CITY OF RAMSEY LAND USE APPLICATION
TECHNICAL REVIEW FILE

DATE	NOVEMBER 23, 2016	PROJECT ADDRESS	NORTH OF ALPINE DRIVE, WEST OF RAMSEY BOULEVARD
PROJECT. TITLE	WOODLANDS 4 TH ADDITION PRELIMINARY PLAT, CUL-DE-SAC LENGTH VARIANCE, AND LOT DEPTH VARIANCE		
ESCROW #			
DEPARTMENT:	Community Development: Planning Division (Zoning Code)		
TECHNICAL REVIEWER:	Name: Eric Maass, Consultant City Planner Phone: (763) 576-4306 Email: EMAass@wsbeng.com

Preliminary Plat Review

We offer the following comments regarding the Preliminary Plat submittal for Woodlands 4th Addition as it relates to the City’s Zoning Code. Preliminary Plat submittal consists of fifteen (15) sheets, prepared by James R. Hill, Inc. dated October 7, 2016. The proposal includes a request for a Preliminary Plat and two (2) variances.

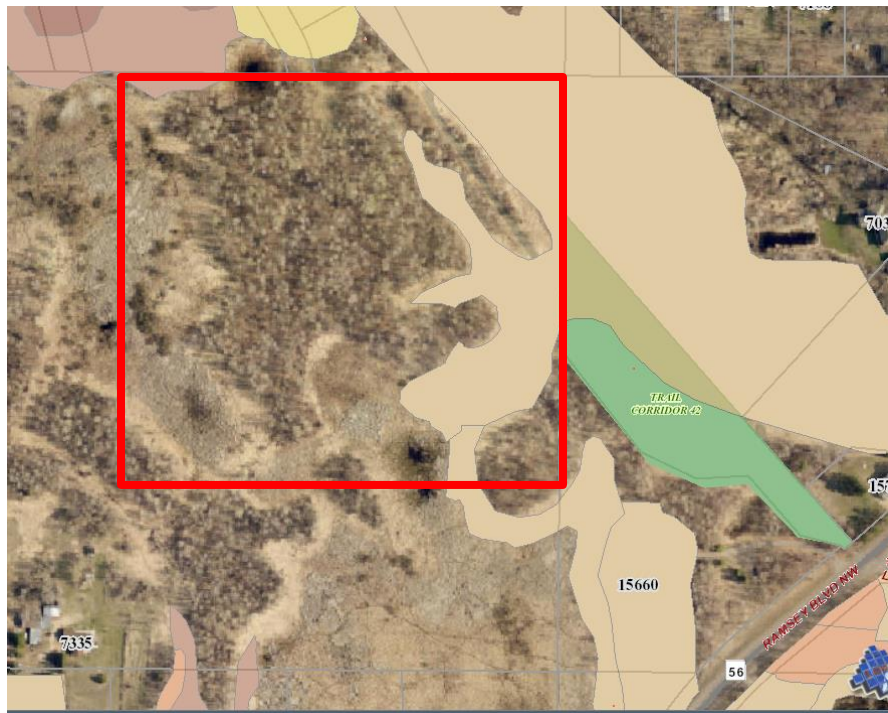
The City’s Natural Resources Inventory (NRI) identifies some moderate quality wetlands and altered/non-native plant communities on and/or very near the project site (site is approximated by the red box).

An existing boardwalk trail follows parallel with Ditch 66 to the west. Staff would like to work with the Developer to ensure a trail connection to the boardwalk from the extension of 159th Ave NW (a mid-block connection).

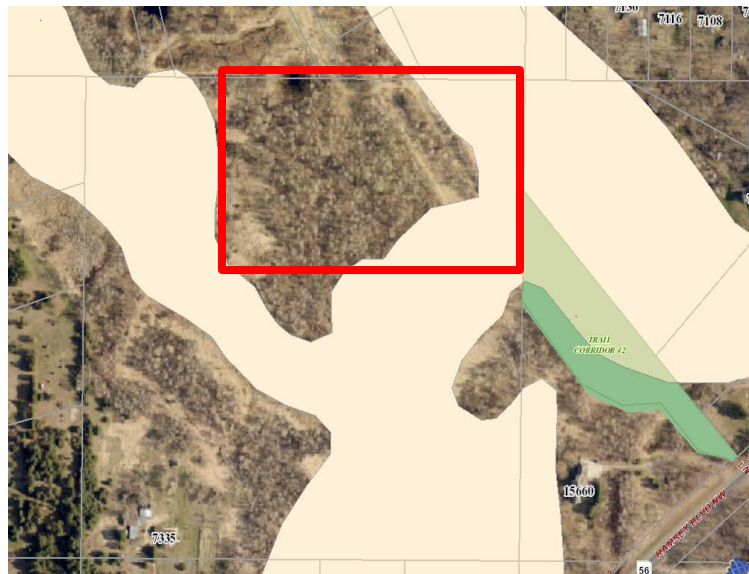
There is floodplain across portions of the project site. There has not been a detailed study completed for this flooding source and therefore, the flood zone is considered to be in the General Floodplain District. This boundary must be identified on the plan set. If there is any disturbance proposed within this floodplain, the Developer must complete a hydrologic and hydraulic analysis to determine the floodway and flood fringe boundaries. The City may require Elevation Certificates for certain lots, prior to the issuance of a Certificate of Occupancy, depending on proximity to the floodplain boundary.
